IICL TB 007, 5 April 2012

Title: LIMITATIONS ON CROSSMEMBER REPAIRS

Reference IICL “Repair Manual for Steel Freight Containers (fifth edition)
Section 8.2.3 Crossmember Inserting
Section 8.4.3 Forklift Pocket Side Inserting

NOT ACCEPTABLE

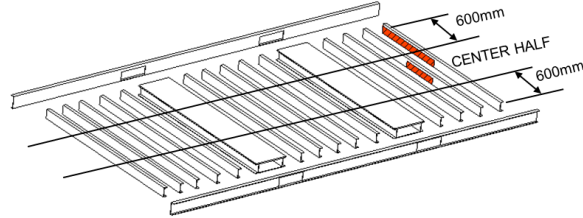
The insert on the right side is acceptable because it is the 1st crossmember with an insert. But the 2nd insert on the left is not acceptable because the weld seam terminates in the center half of the container.

Weld repairs to members (crossmember / forklift pocket side wall) are not allowed within the center one half of two adjacent members. The center one half of a member is defined as that part of the member that is greater than 600mm from the nearest bottom side rail. If two adjacent members have weld repairs within the center halves, either one of the members must either be replaced or the inserts must be lengthened such that they do not terminate within the center half of the member.

NOT ACCEPTABLE

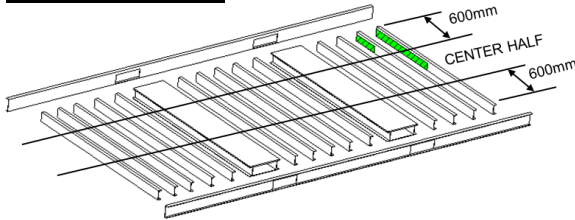
The insert on the right side is acceptable because it is the 1st crossmember with an insert. The 2nd insert on the left is not acceptable because the weld seams terminate in the center half of the container.

ACCEPTABLE

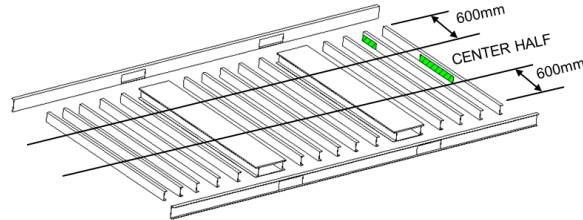
The insert on the right side is acceptable because it is the 1st crossmember with an insert. The 2nd insert on the left is also acceptable because the weld seams terminate within 600mm from the bottom side rail.

ACCEPTABLE

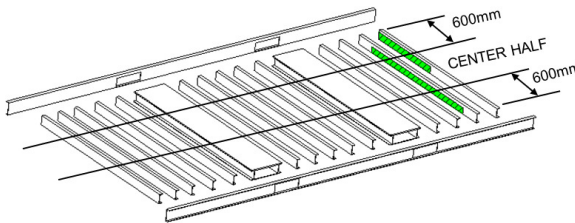
The insert on the right side is acceptable because it is the 1st crossmember with an insert. The 2nd insert on the left is also acceptable because the weld seams terminate within 600mm from the bottom side rail.

ACCEPTABLE

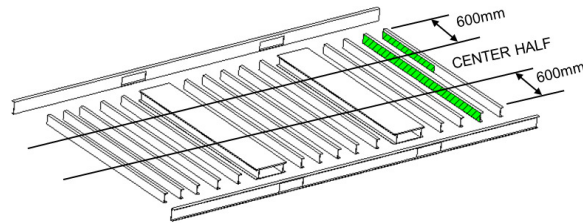
The insert on the right side is acceptable because it is the 1st crossmember with an insert. The 2nd insert on the left is also acceptable because the weld seams terminate within 600mm from the bottom side rails.

FULL CONTAINER EXAMPLE

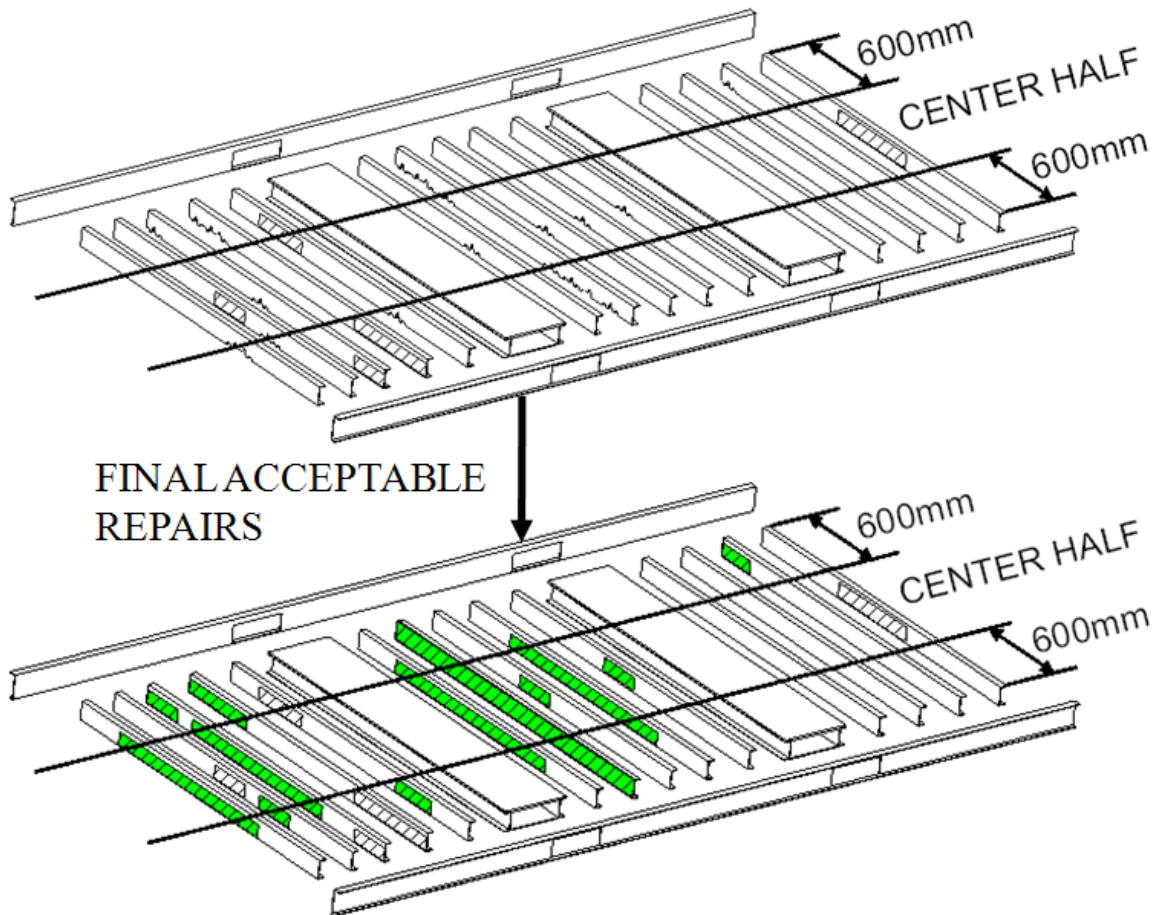
AN EXAMPLE of new damage locations and pre-existing inserts.

Acceptable inserts based on new damage locations and pre-existing inserts, as shown above. It is important to note that this is one EXAMPLE of a possible combination of damage and acceptable repair inserts. There may be many different possibilities. This drawing should only be used as a guide to determine the safest and most economical type of repair on a case by case basis.
